SUNNICA ENERGY FARM

EN010106

**8.52 Update by the Applicant on Heritage Matters and Substation
Connection**

Version	Date	Status of Version
Rev 00	28 November 2022	Deadline 3A Submission

Appendix C Plan C: Area to be excluded from W-04

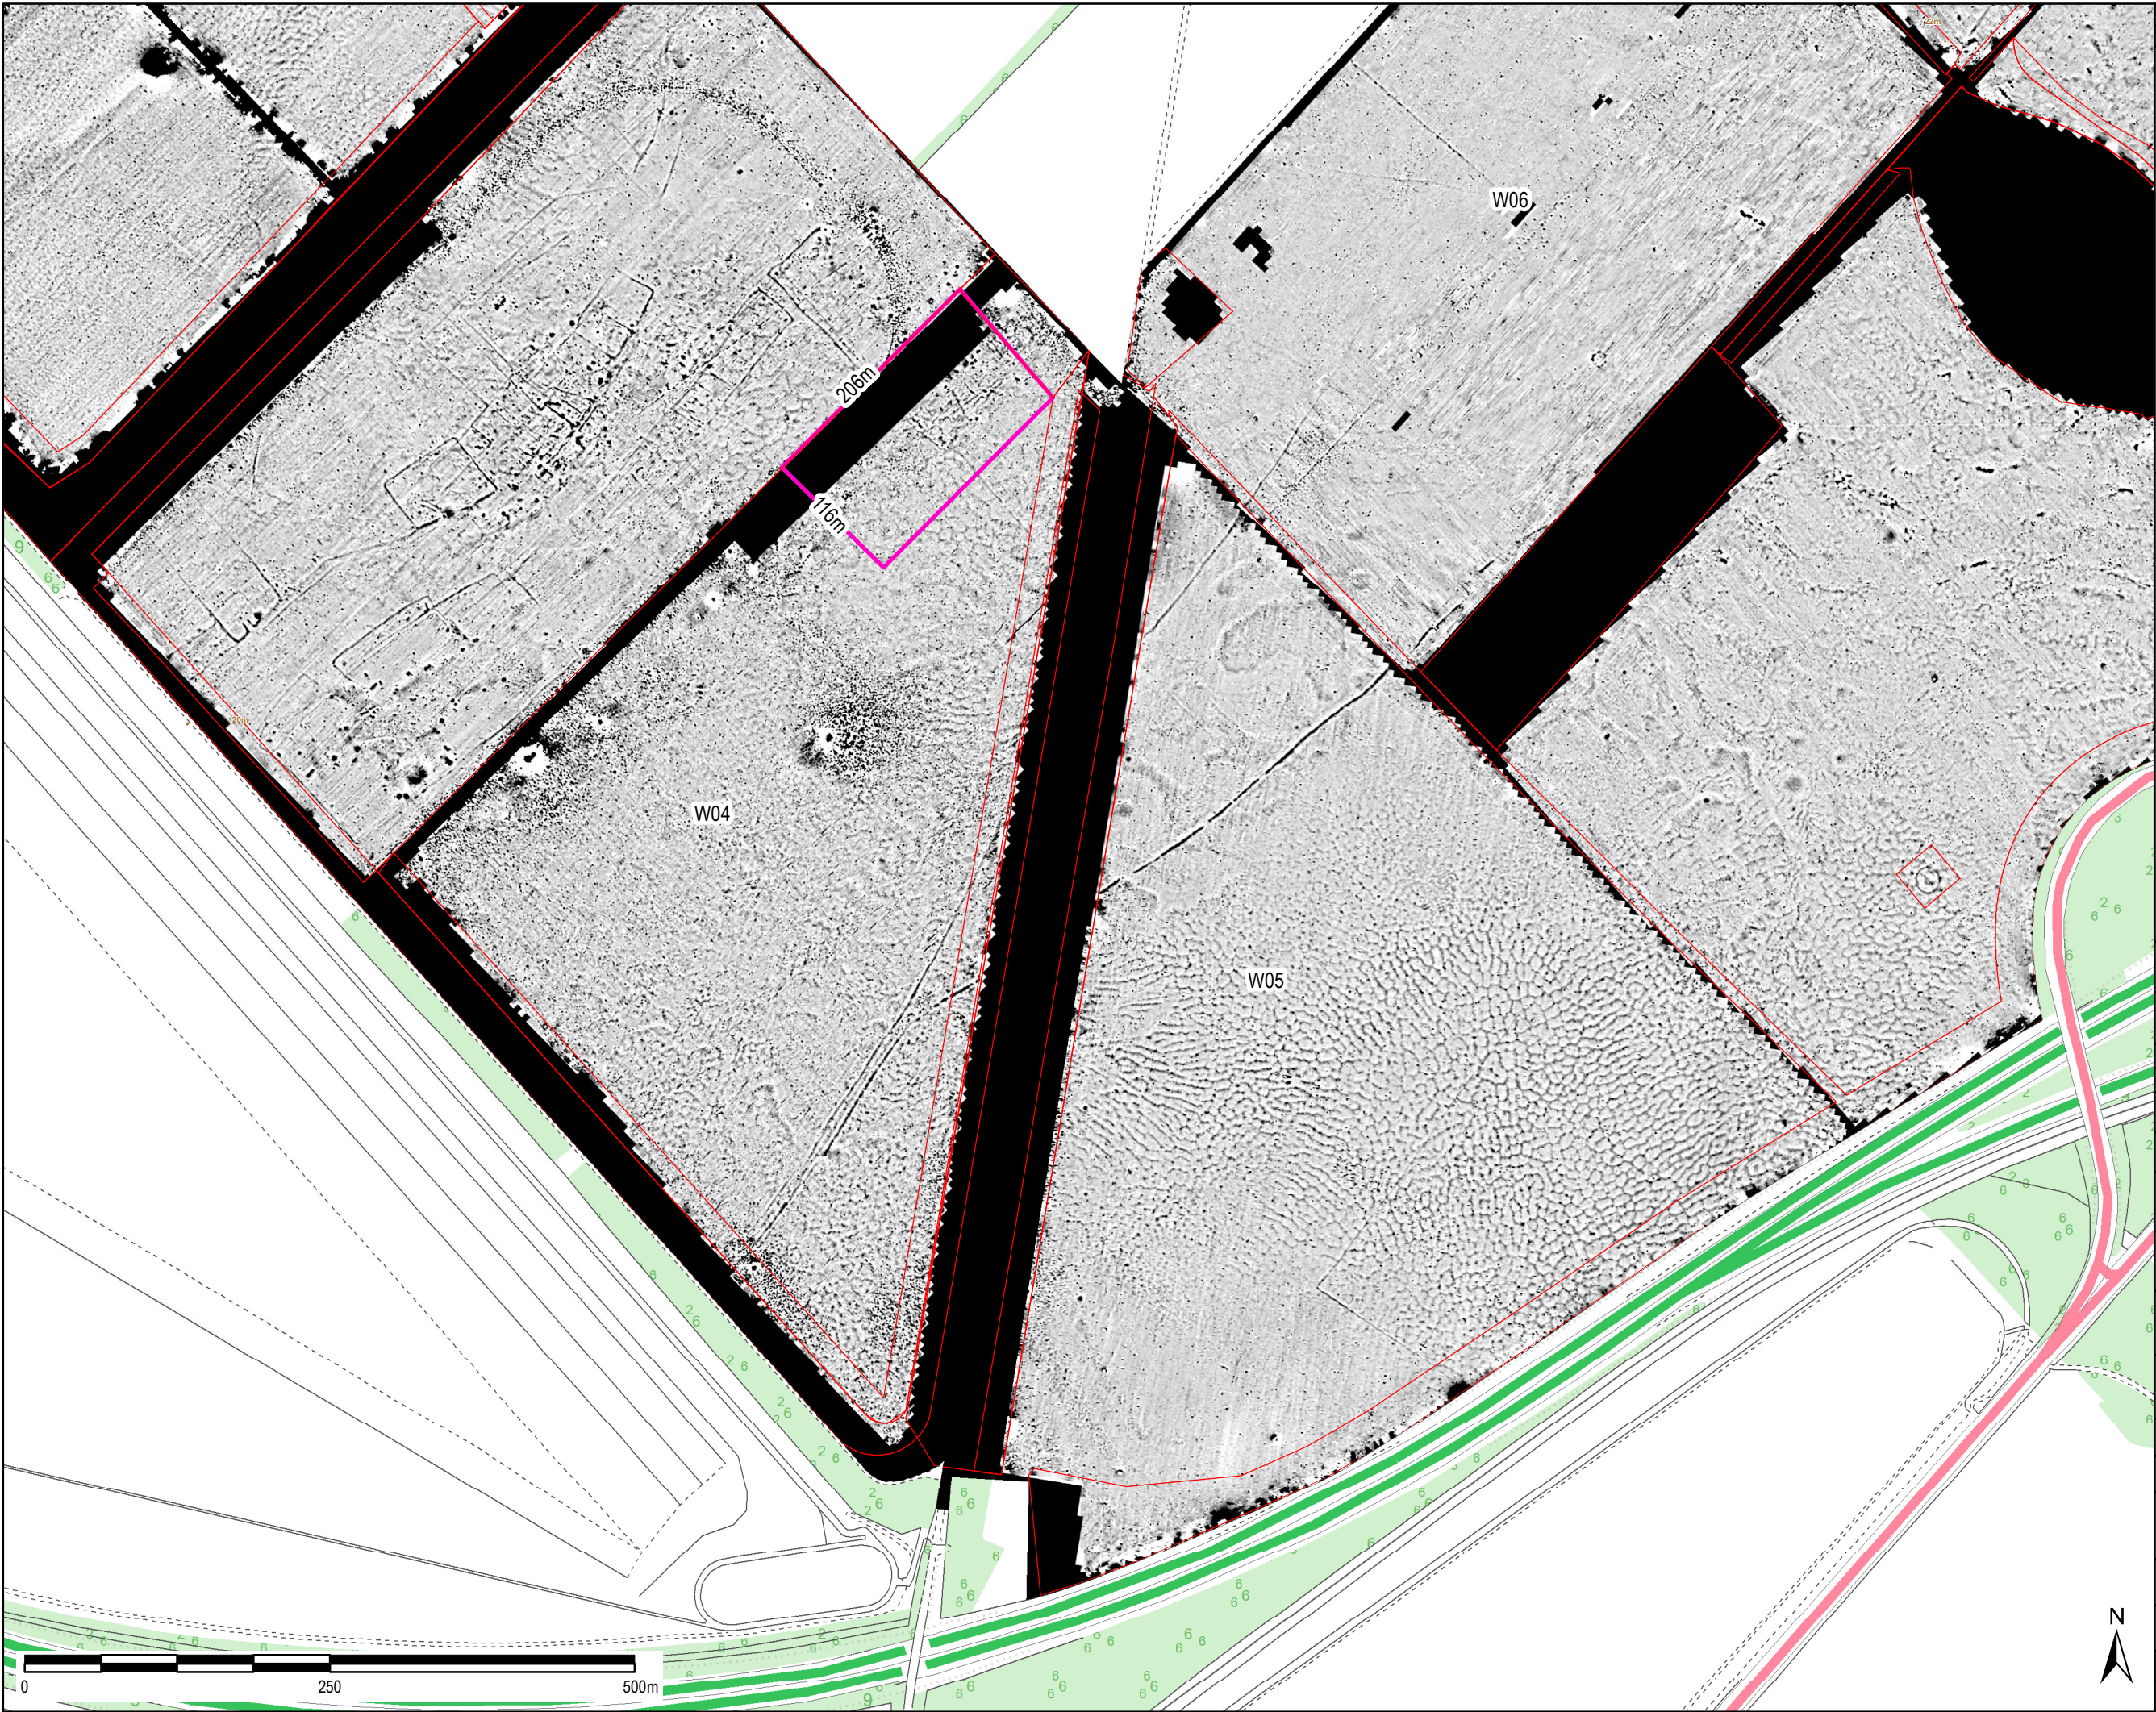
5.1.1 The results of geophysical survey in the northern part of W04 indicate an area of concentrated archaeological features that represent an extension to the area already proposed for archaeological preservation to the immediate West of W04. Although it has not been highlighted in the RR or LIR, Cambridgeshire Council Historic Environment Team ("CCHET") have recommended in previous consultation meetings that this area to be omitted from the development.

5.1.2 The Applicant is willing to exclude (via changes to the Works Plans and for the purposes of this note appended at Plan C) an area encompassing the concentration of features in the north of W04 as the remains are likely to be associated with settlement features in the area excluded from development to the immediate west. The Applicant agrees that preserving the concentration of settlement features in the north of W04 in situ would be appropriate on archaeological grounds.

- a. the power generation created by the Scheme would be reduced by the total of the area within the extended mitigation area which is approximately 2.39 Ha. Therefore, an estimate of approximately 2.4MWp installed capacity solar PV would be removed from the overall installed capacity of the Scheme.
